Submission for Job: #6011 SSD 6011 - Mixed use residential development within the South West Plot

Site: #2825 SICEEP Site, The Haymarket; Darling Drive, Sydney

SSD 6011 - Mixed use residential development within the South West Plot

1. Belated provision of overshadowing diagrams in elevation and consequent timing of this submission

LEVEL 6

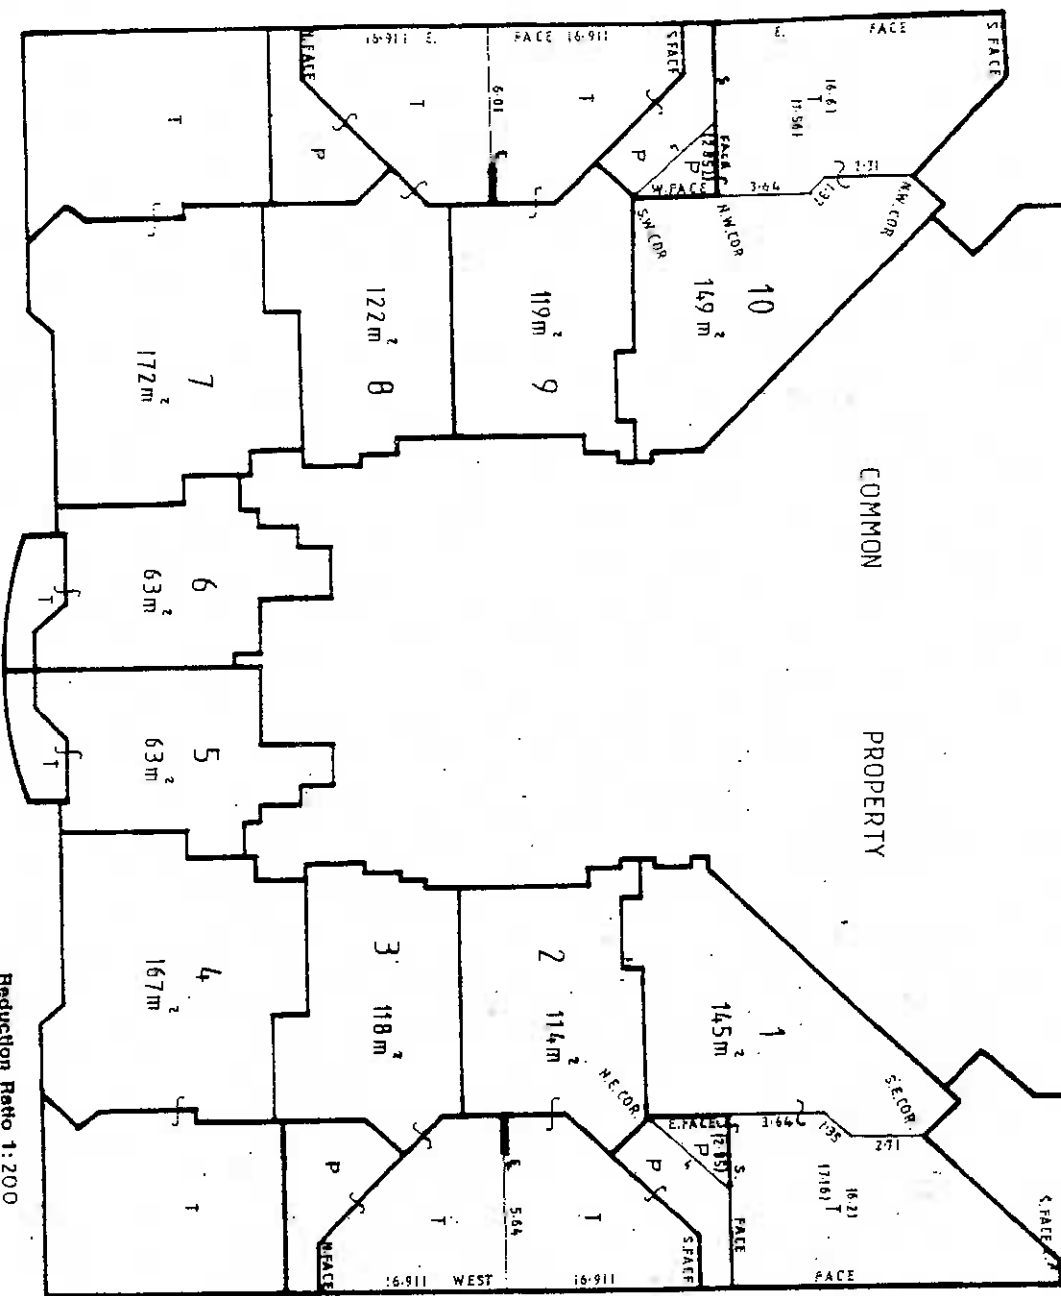
Levels 6 and 7 each contain two apartments with single west aspect , i.e. 4 single aspect apartments.

LEVEL 8

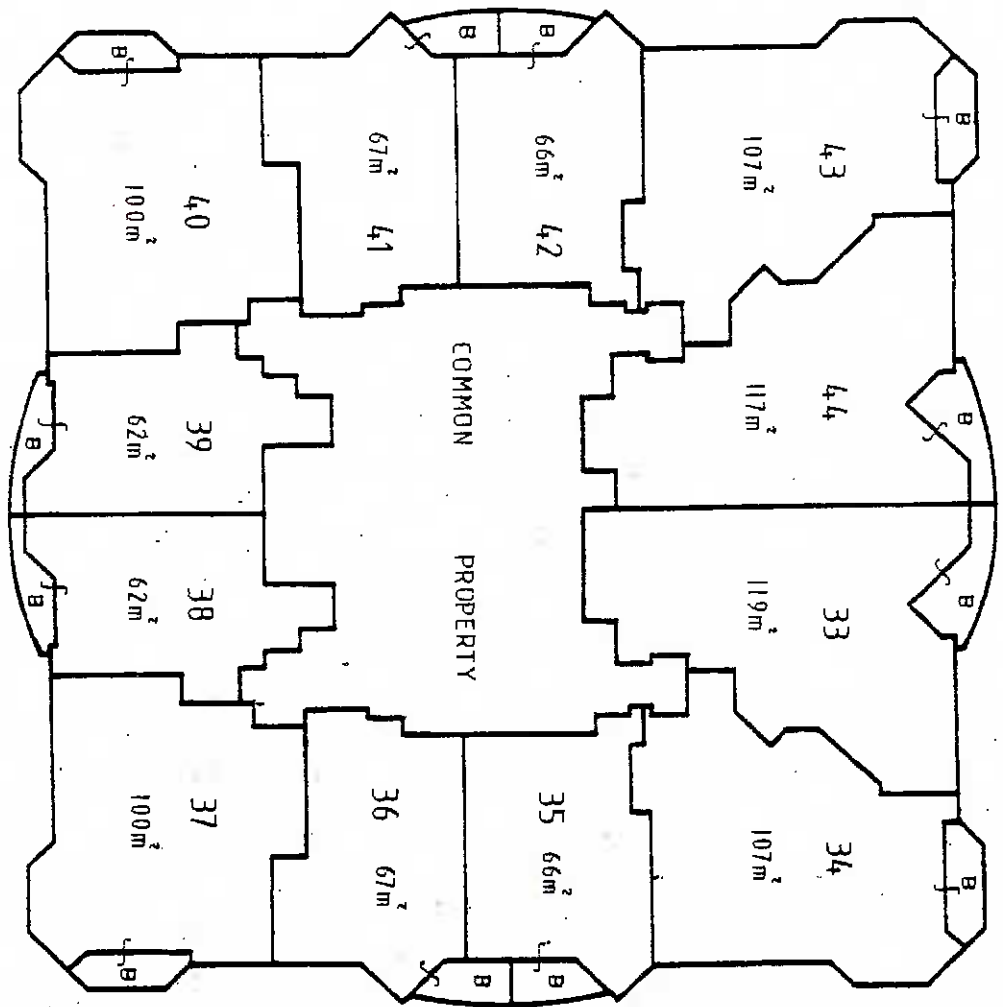
Levels 8-15 each contain two apartments with single west aspect and two apartments with single north aspect , i.e. 4 single aspect apartments per level, giving 32 single aspect apartments.
